6632B-08

S E R V I C E N O T E

Agilent 6632B DC Power Supply

On faster computers, when programming over GPIB, a random error will occur.

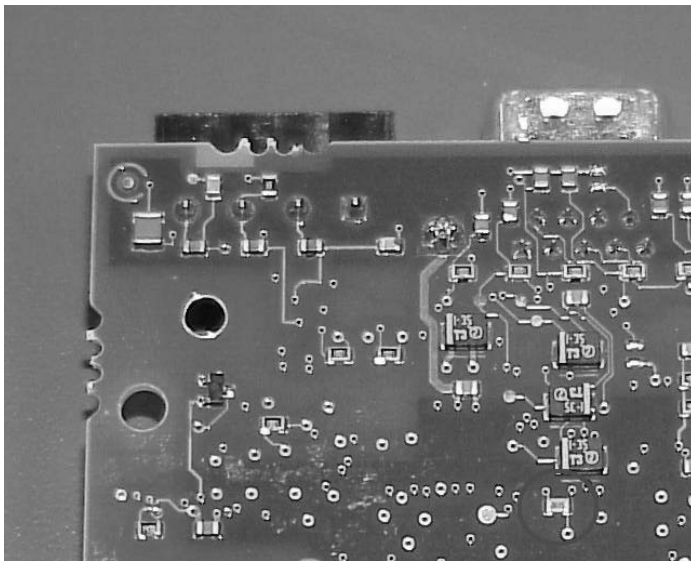
When programming a unit over GPIB, a random error -113 (“Undefined header”) will appear on the unit. This error can be read back via the front panel or over the GPIB bus.

Change resistor R1246 (see picture for location) from 511 Ohms to 100 Ohms (part number 0699-3058). This requires un-soldering and soldering a surface mount component and can be very difficult. This does not require re-calibration.
